THE CITY OF WALTHAM
MASSACHUSETTS

**Storm Drain Improvements Project
Weston/Vernon Street Area**

ADDENDUM NO. 2

August 25, 2014

Project	Sheet
Date AUG 2014	C-101
Scale 1" = 20'

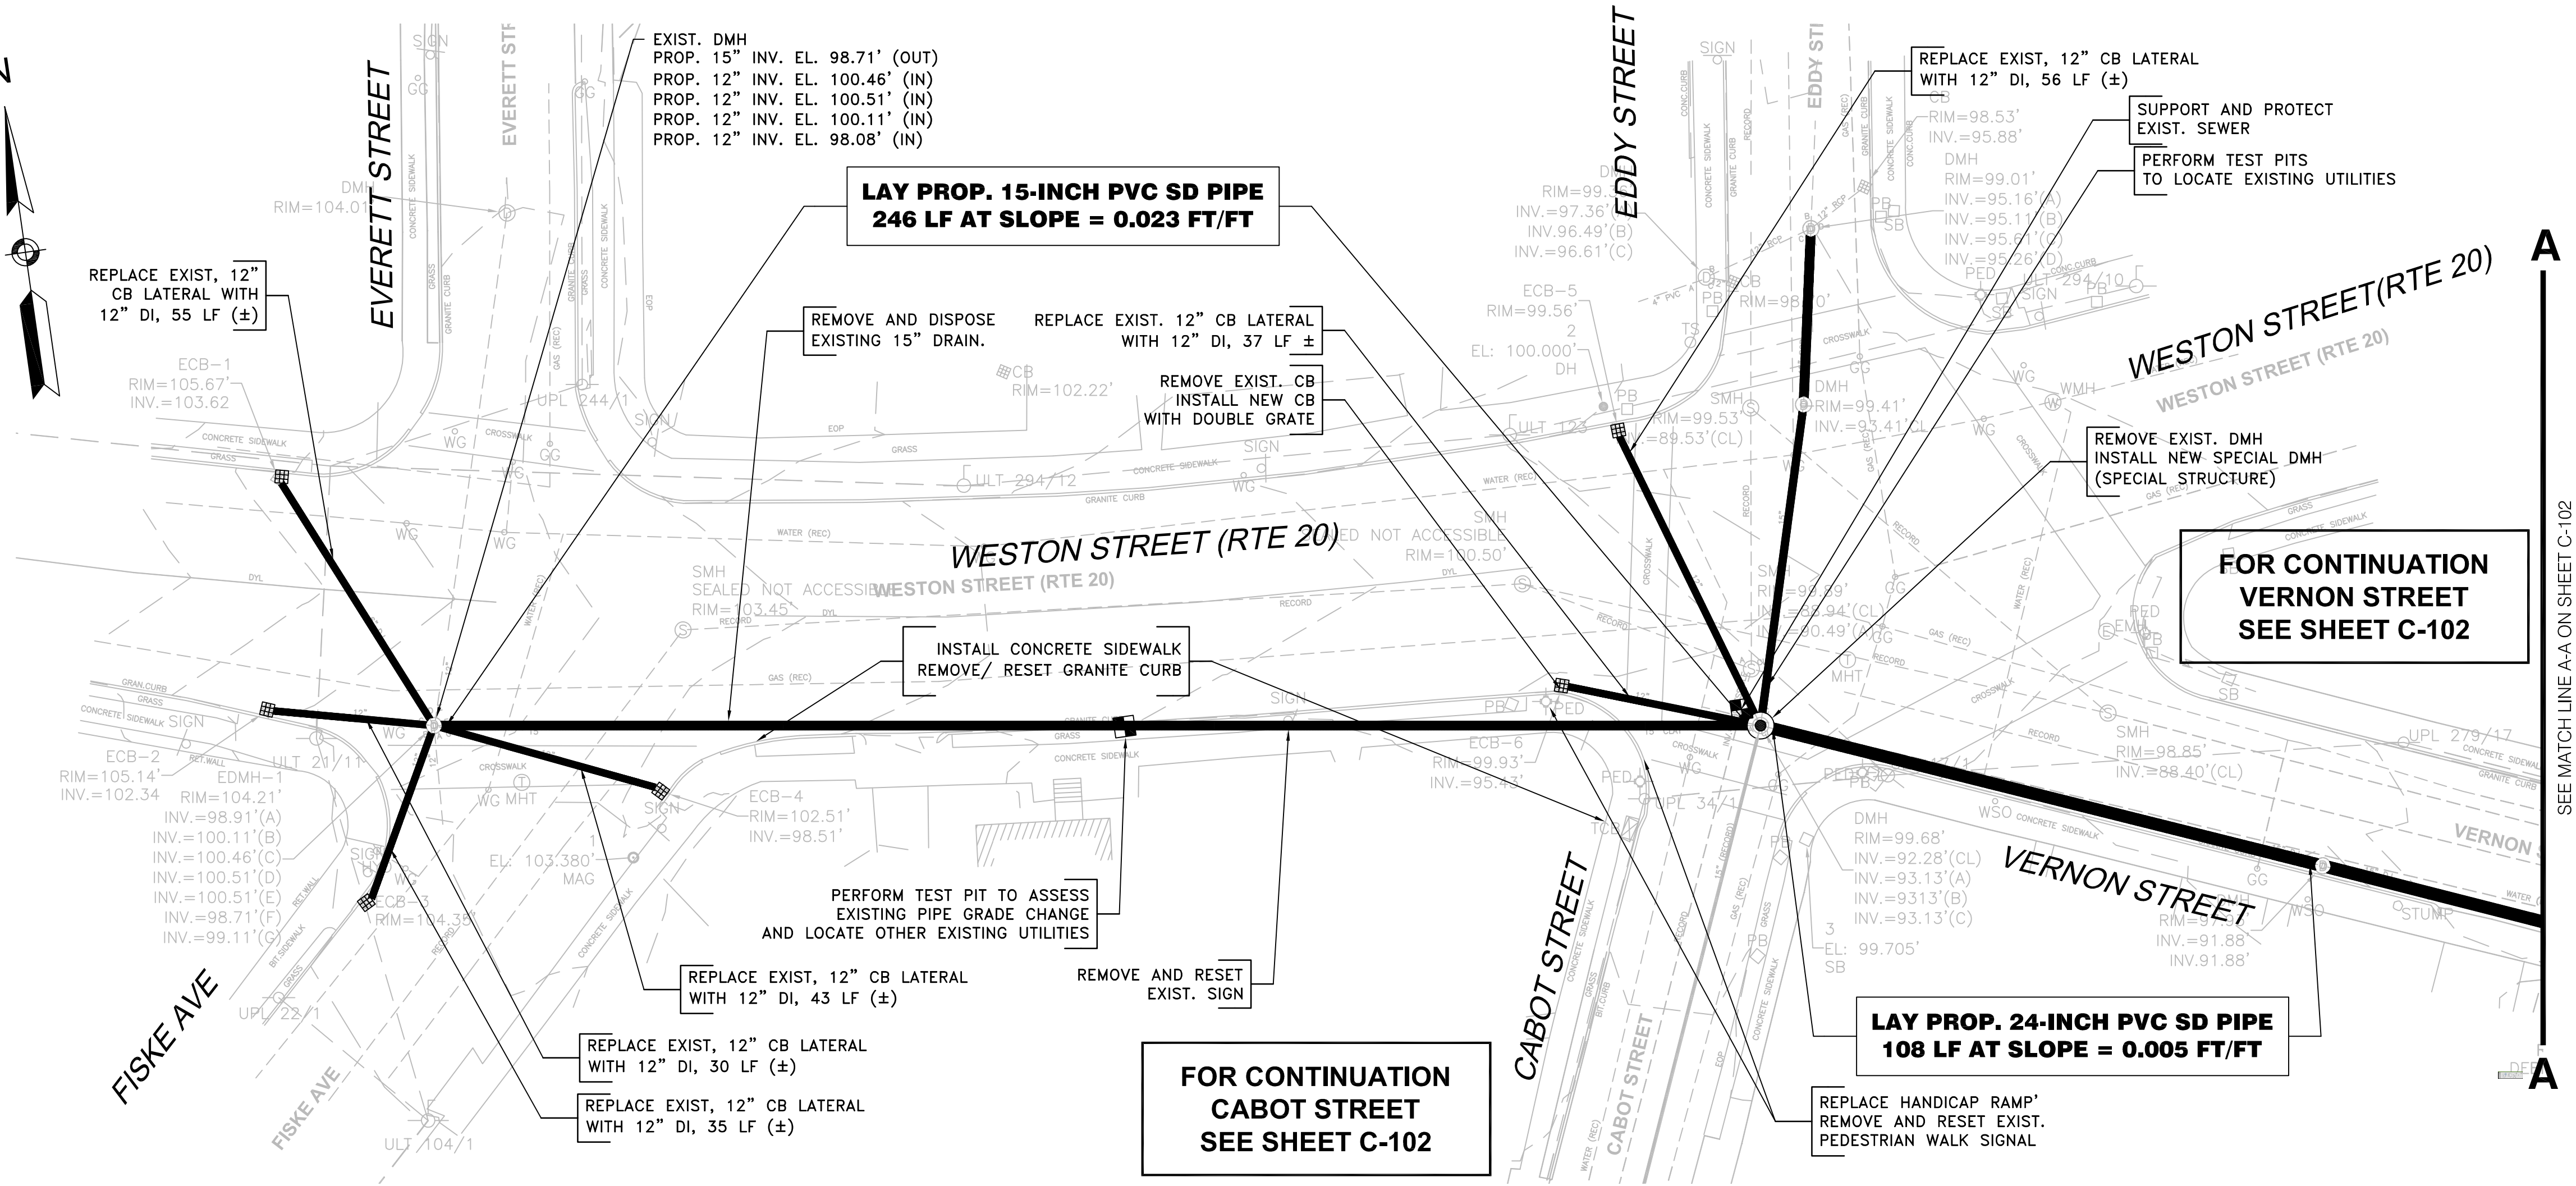
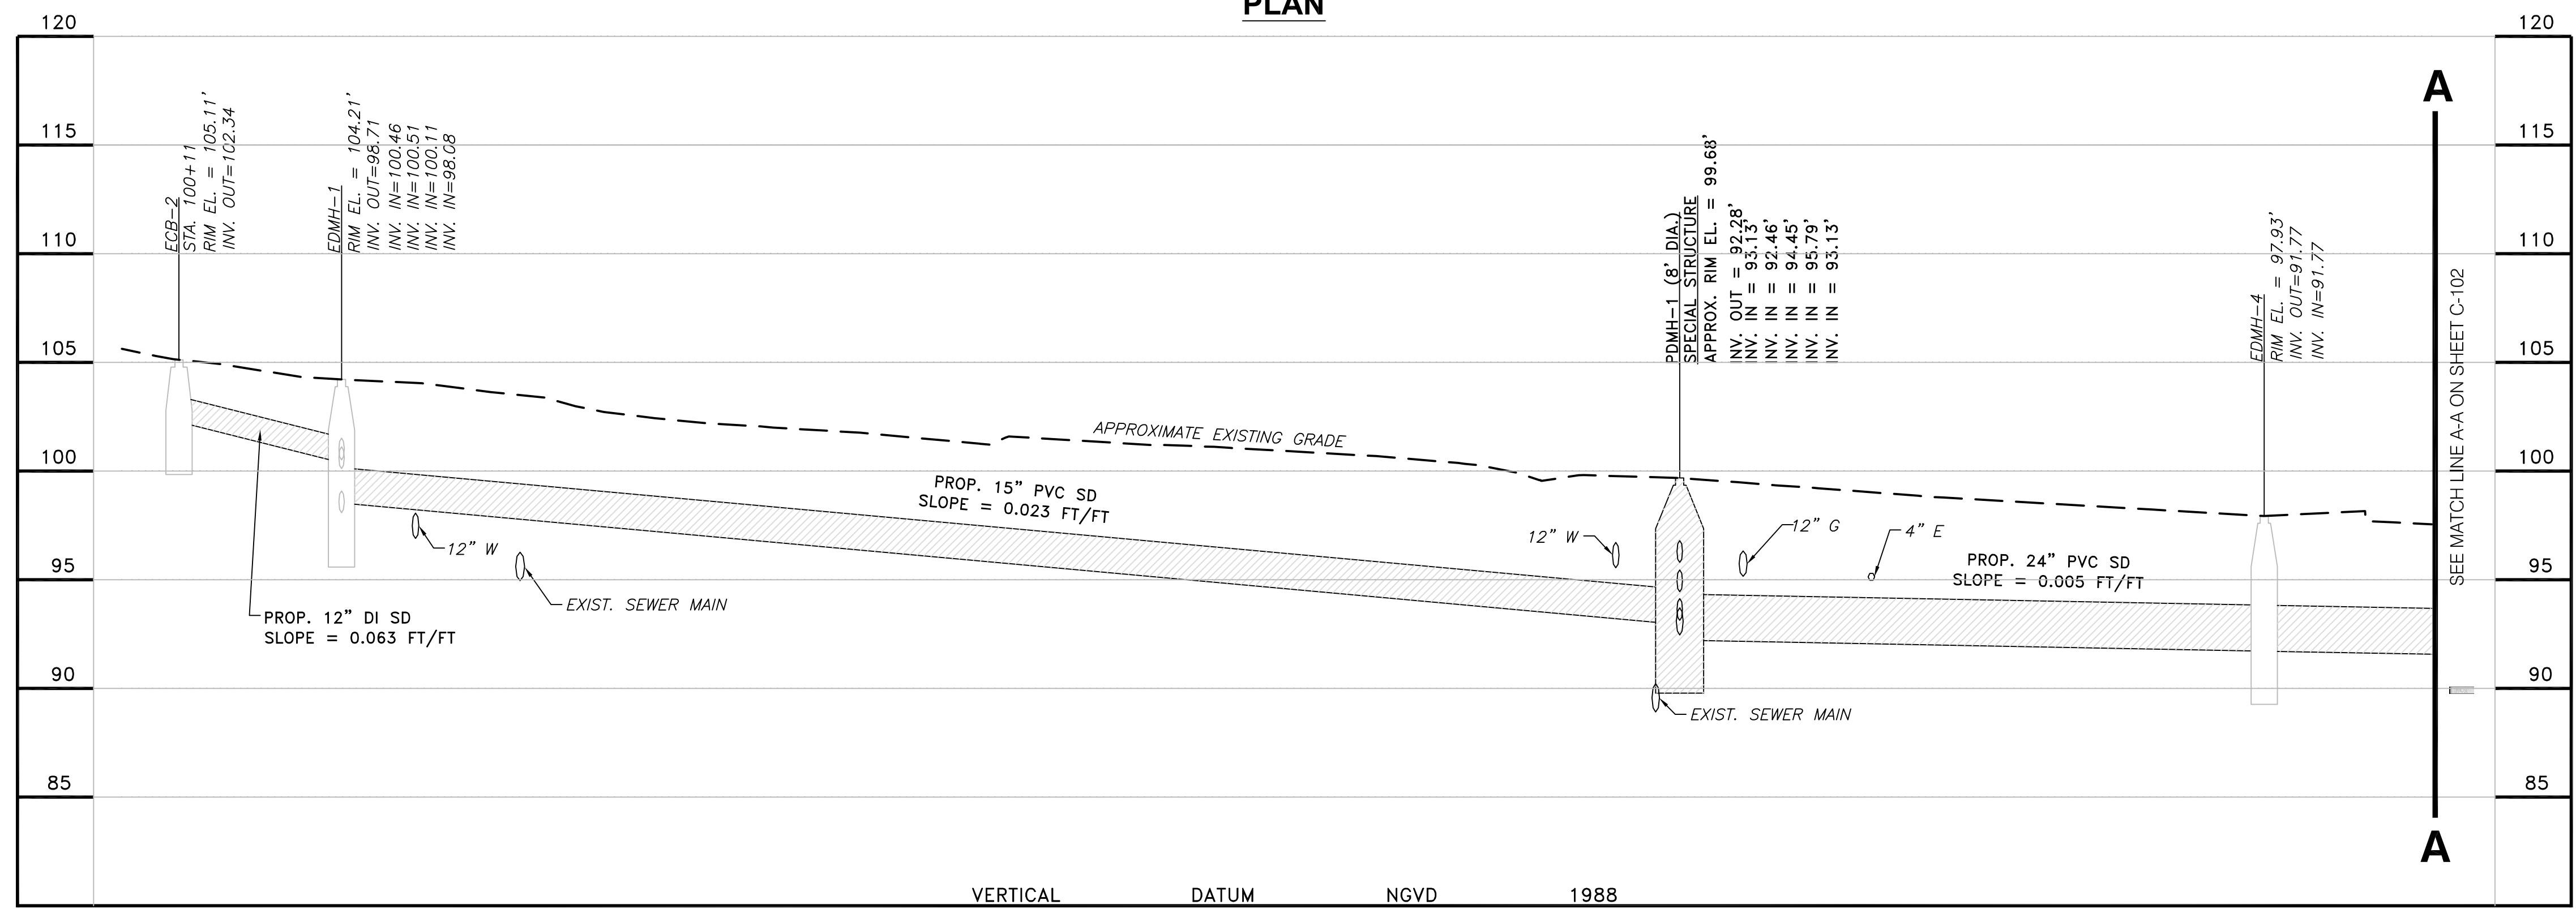
Q1. The preliminary drawings do not include the existing drain invert and rim elevations.

- Replace existing CB lateral at #102 Weston Street to DMH on Weston street/Fiske Avenue.
- Replace existing 15-inch main drain from DMH on Weston Street at Cabot Street to DMH in the sidewalk just west of #112 Vernon Street and replace with 24-inch PVC SDR 35 pipe.

A1. Please see the design drawings included with this Addendum.

141.000.B – TRENCH PAVEMENT DETAILS

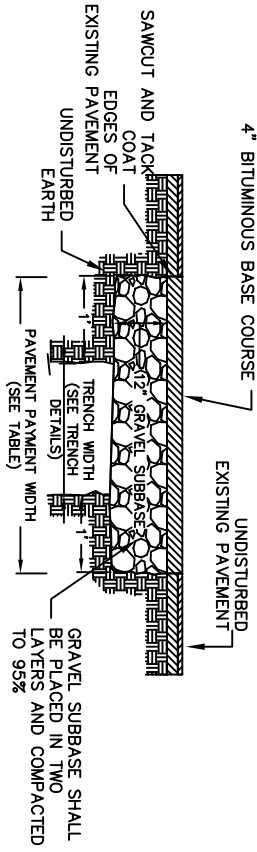
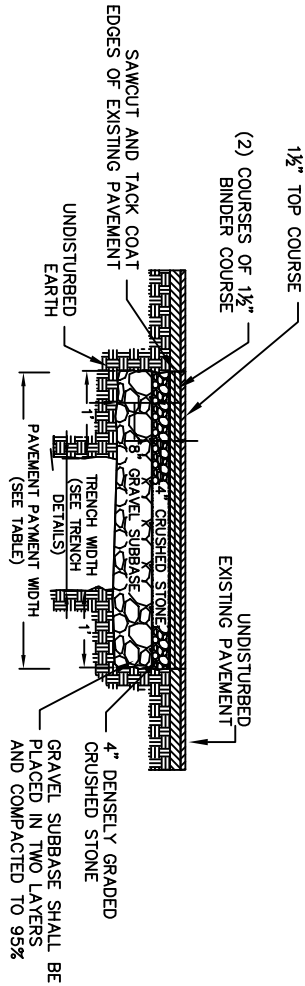
5. **ADD Section 02622 Polyvinyl Chloride Gravity Pipe** that is attached and part of this Addendum.
 6. **ADD Construction Detail 141.000B Trench Pavement Details** that is attached and part of this Addendum.
